Staff Report & Recommendation

Design Review Board

SUBJECT: DRB17-0163
330 76th Street – Townhomes

Current property view.

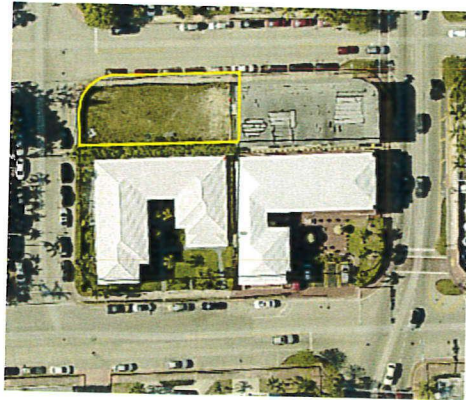
The subject property is a corner lot located in a block originally platted with 6 parcels. In this block, the two parcels facing 76th Street have remained as single lots and the adjacent sites to the south have joined developments including the interior lots. Other blocks in the area between 75th Street and 76th Street have similar conditions and were originally platted with smaller lot sizes than those typically found in the RM-1 zoning district. Without the granting of this variance, the construction of the proposed building would not be permitted and the site could not be developed as other lots in the same district. Based on the special conditions of the site, staff has no objections to the approval of variance #1 as it is the absolute minimum variance necessary to develop the site.
